# PLANNING DEPARTMENT RESPONSE TO APPEAL OF FINAL MITIGATED NEGATIVE DECLARATION

# **570 MARKET STREET**

RE: Appeal of Final Mitigated Negative Declaration of 570 Market Street

Planning Case No. 2019-017622ENV and 2019-017622APL

**Figure 1:** Satellite view of surrounding mid- to high-rise development.

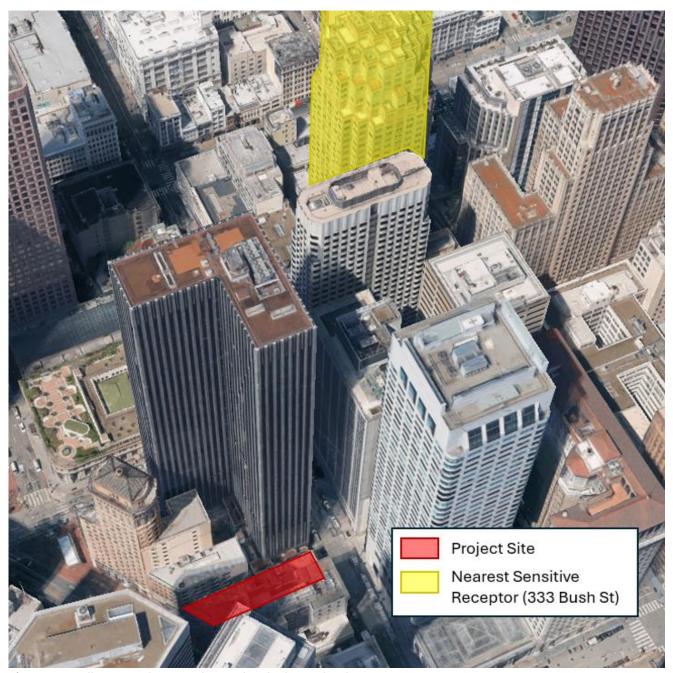
The appellant further contends that due to the presence of mid- to high-rise buildings in the vicinity, construction noise has the potential to reflect off neighboring buildings and amplify sound. However, the neighboring buildings are oriented in such a way that construction noise from the project site would likely be reflected away from the nearest sensitive receptor (i.e., residences at 333 Bush Street approximately 450 feet away) and is unlikely to be amplified – see Figure 1. The appellant has not explained how the surrounding buildings would amplify sound to the nearest sensitive receptor. The appellants have also not provided any substantial evidence or noise calculations to demonstrate how sound might be amplified at nearby commercial receptors; such a calculation would involve numerous variables such as what the composition of nearby building materials, the location of the construction sound source relative to the receptor, the angle of

nearby buildings that could reflect sound, and more. Therefore, the appellant's contention is speculative and does not support a fair argument.
